Issue Date: **July 23rd, 2025**

Reference: **LFPI250723**

This notice is to inform you about adjustments on the outline drawing for the package TO-240 that may affect selected items that you have purchased from Littelfuse.

Package TO-240

Basic outline drawing

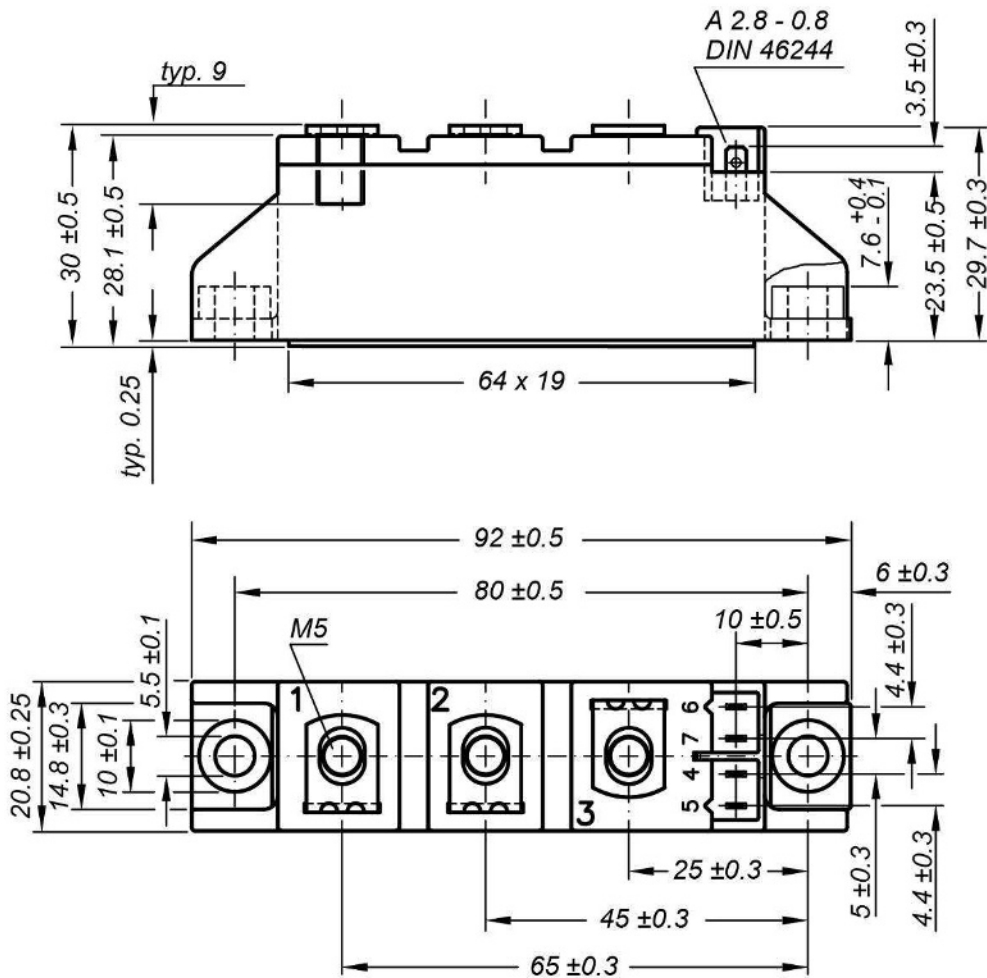
- Small adjustments for sizes and tolerances; important values listed below
 - Total height: from 30,2 mm +- 0,8/0,2 mm into 30,0 mm +- 0,5 mm
 - Height of plastic case: from 28,5 mm into 28,1 mm +- 0,5 mm
- A value for the depth of the terminal mounting hole integrated.
- All sizes that had no tolerances in the former outline drawings are now with tolerances.
- No changes in Fit, Form or Function
- No change in Bill of Material
